# NOTICE OF DECISION

**REPLAT TENTATIVE PLAN / CLASS 3 SITE PLAN REVIEW / CLASS 2  
ADJUSTMENT / TREE AND VEGETATION REMOVAL PERMIT CASE NO.: REP-  
SPR-ADJ-TRP24-07**

**NOTICE OF DECISION DATE:** December 16, 2024

**SUMMARY:** Development of a new multi-family apartment complex.

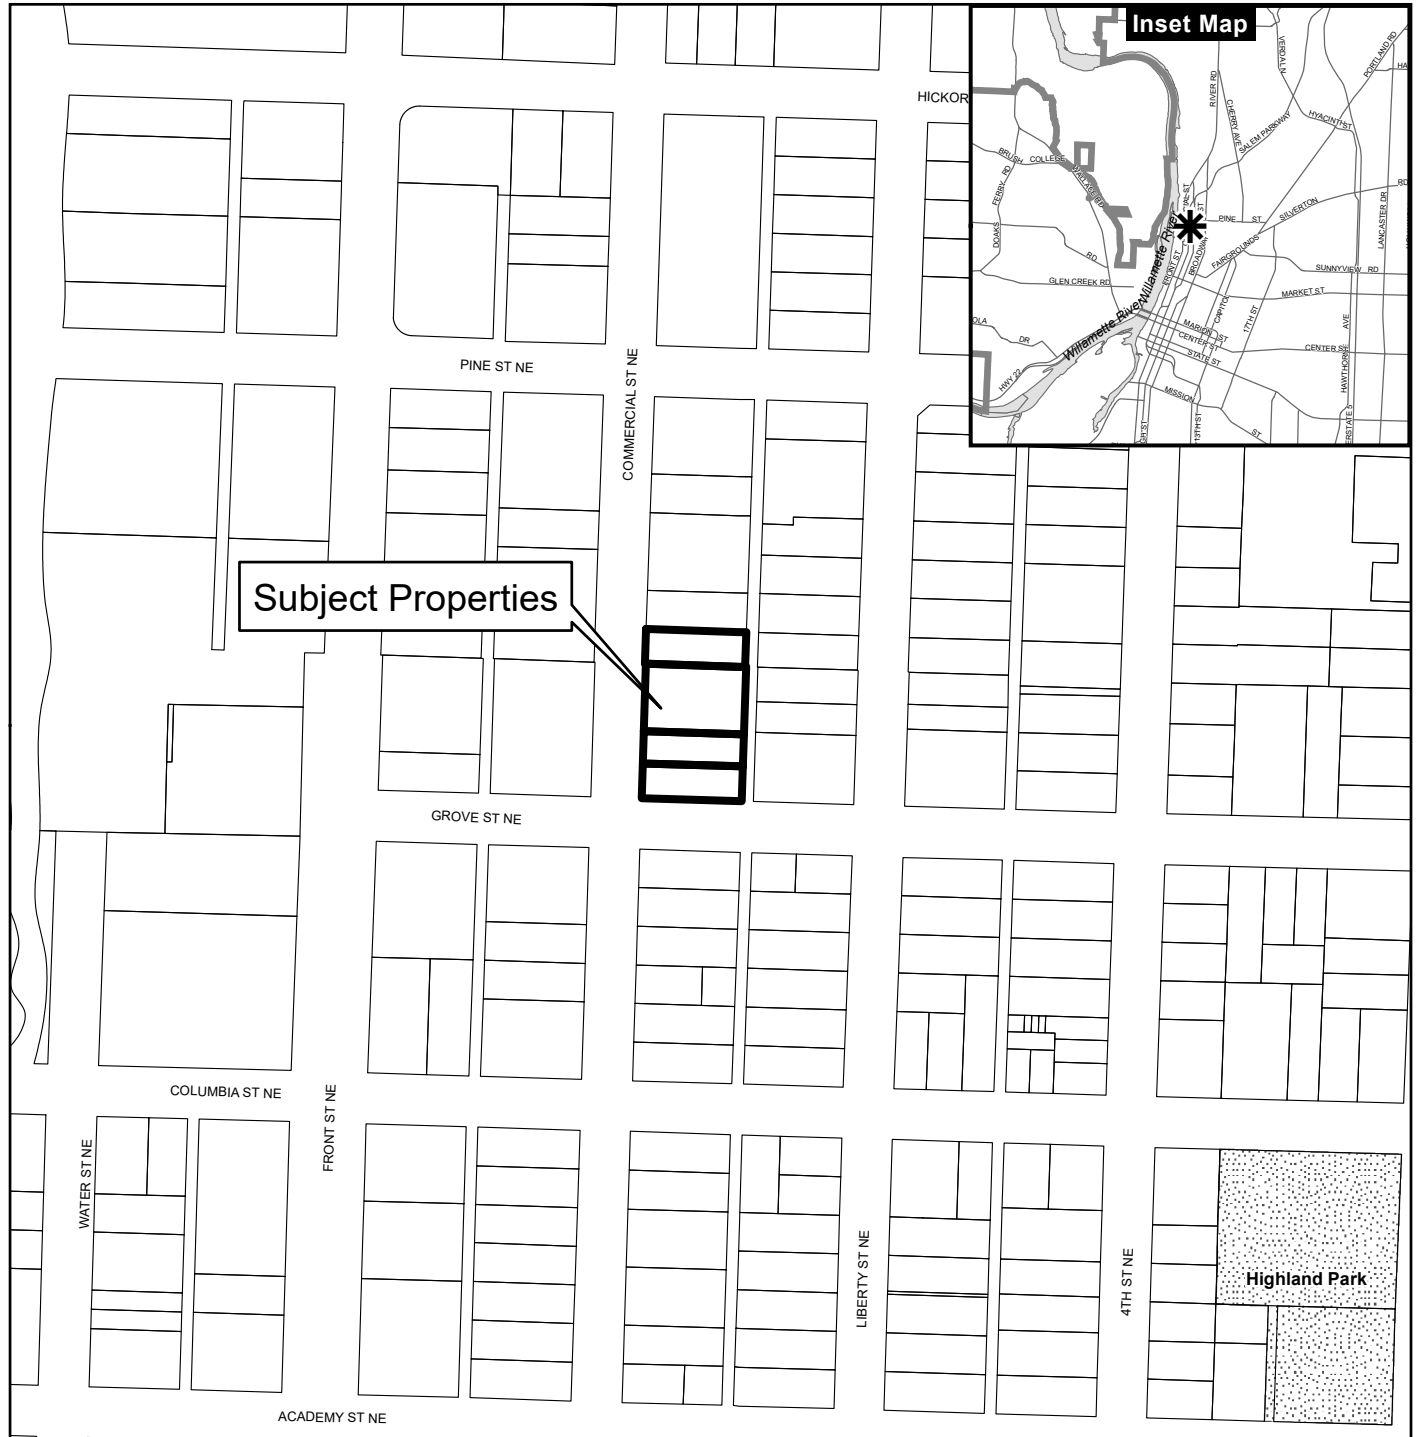
- Condition 15:** The development standards in these zoning adjustments shall only apply to the specific development proposal shown in the attached site plan. Any future development, beyond what is shown in the attached site plan, shall conform to all applicable development requirements, unless adjusted through a future.

- Condition 15:** The development standards in these zoning adjustments shall only apply to the specific development proposal shown in the attached site plan. Any future development, beyond what is shown in the attached site plan, shall conform to all applicable development requirements, unless adjusted through a future.

# PROPOSED SUBDIVISION PLAT

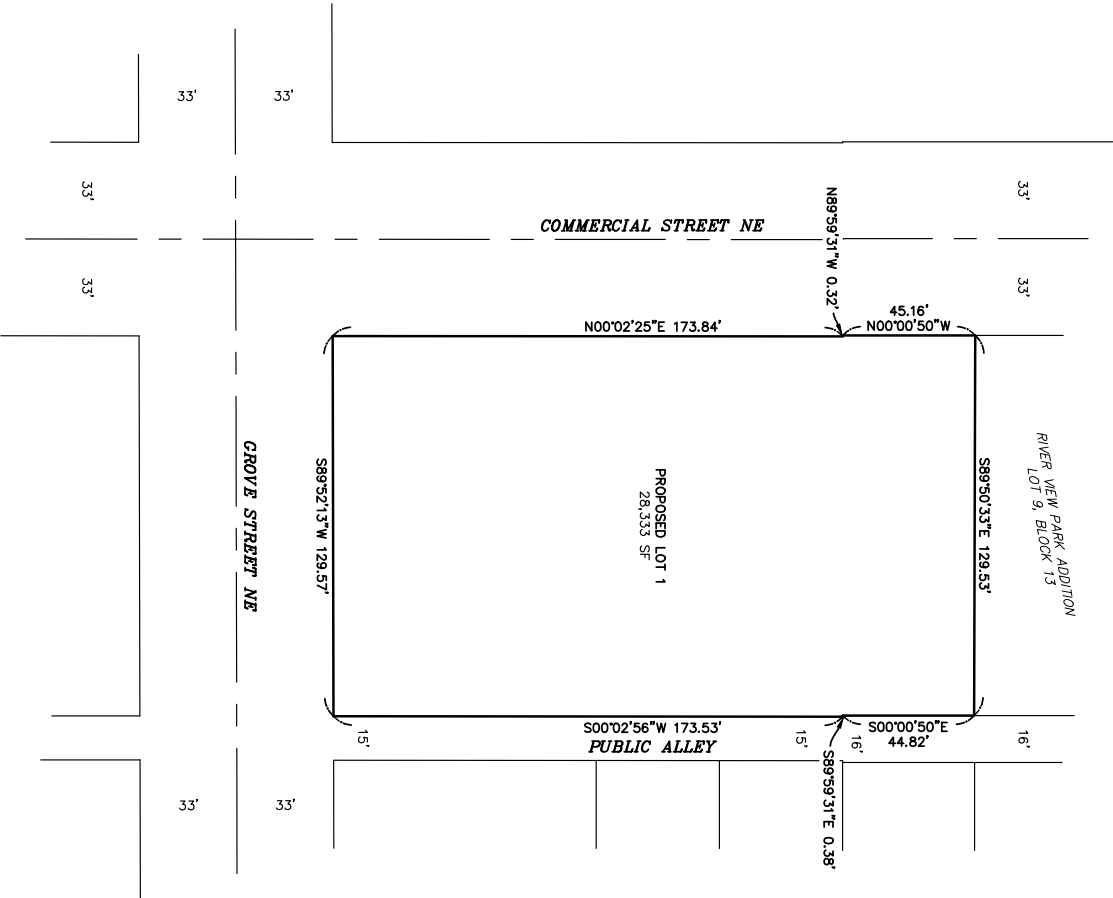
**Condition 14:** Prior to issuance of a Certificate of Occupancy, widen the unnamed alley and approach to Grove Street NE to a minimum 20-feet and construct the approach to meet PWDS Drawing 302 for Commercial Approaches. The alley shall be widened to 20-feet from the intersection of Grove Street NE and the Unnamed Alley to northern property boundary.
